CERTIFIED SURVEY NO. 1578
DOCUMENT NO. 1414996

Plat of Survey
D'ONOFRIO, KOTTKE AND ASSOCIATES, INC.
MADISON, WISCONSIN

From: Mancheski, Jean - DOT [jean.mancheski@dot.wi.gov]
Sent: Thursday, February 13, 2014 10:09 AM
To: Quamme, Jeff; Anderson, Patrick
Cc: Tucker, Matthew; Pederson, Eric
Subject: RE: 6301 Odana/CSM 1578

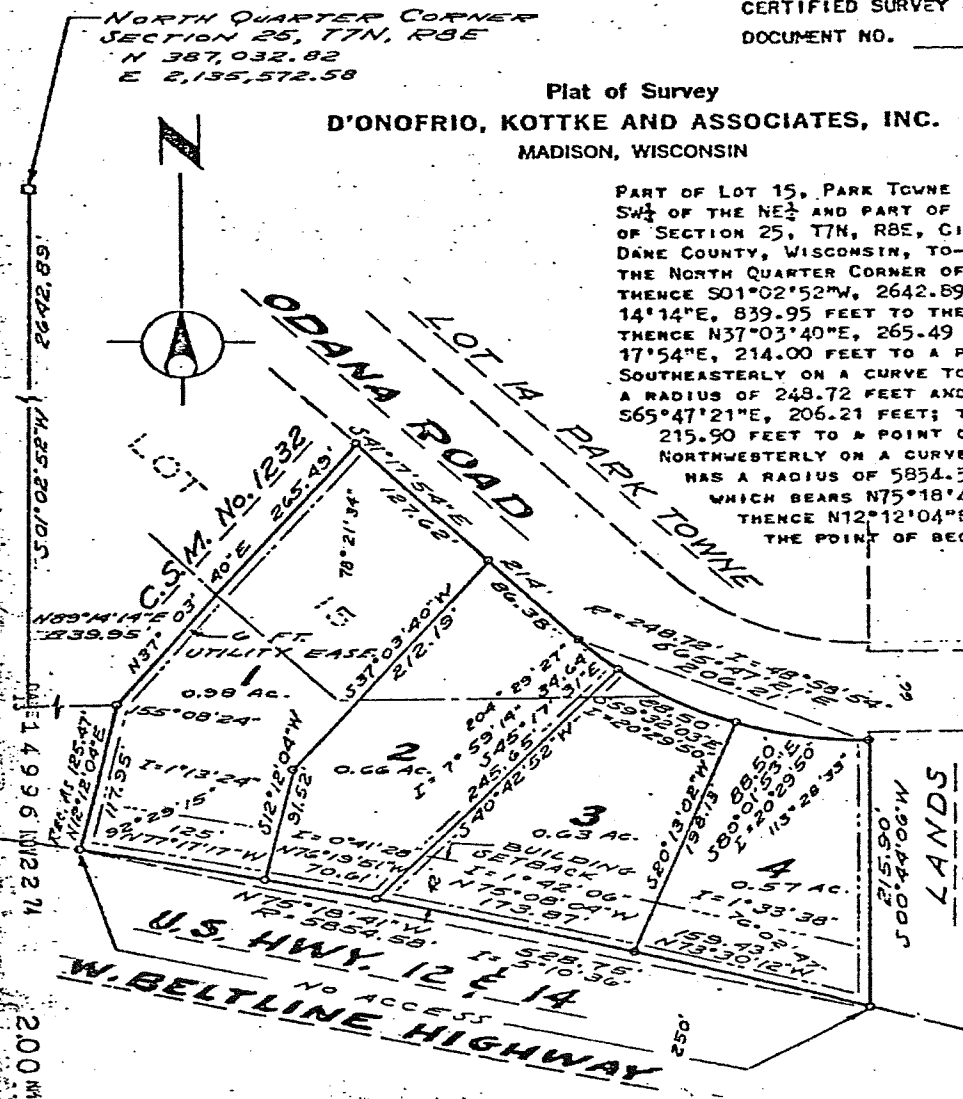
see attached email from DOT. Building setback line is not enforceable by the DOT

Attached is an older Certified Survey Map (1578) in the City of Madison. CSM's at the time of recording were not submitted to the DOT for review. But there is a 42' building setback line (not denoted a highway setback line) shown on the Certified Survey Map.

Proposed development on the property(s) would require the release of the 42' setback line.

Before the discussion goes much further, we would like to confirm whether this is a setback enforced by the DOT or not. My inclination is it is not, but would prefer to make sure before moving ahead.

The 42' setback from the beltline the CSM? If St. Vinneys would like to do an addition to their building showing a setback of less than 42'. Is this something that is commonly done? Will this require a Counsel resolution action to amend the existing CSM or a new CSM? Do you have a contact at District 1? We will likely see them at DAT as the addition will include the demo of The Leather Furniture Place for parking?

Based upon the documents that WisDOT reviewed, I am unable to verify that WisDOT imposed the setback on the plat of survey.

That being said...the Beltline is a major highway and it is quite likely that the r/w will be expanded at some point in time. Therefore in an effort to protect all parties involved, WisDOT would like to respectfully caution the City as to what you choose to allow in the setback area.

There is not any indication of this being a setback line required specifically by the DOT in any certificate or in the notes for the setback itself. HY 33 (now TRANS 233) did have setback requirements, see section 33.08, but again it would have applied to platted areas only and not CSM's.

The modification to the setback would have to be accomplished with a Resolution approved by the Common Council.
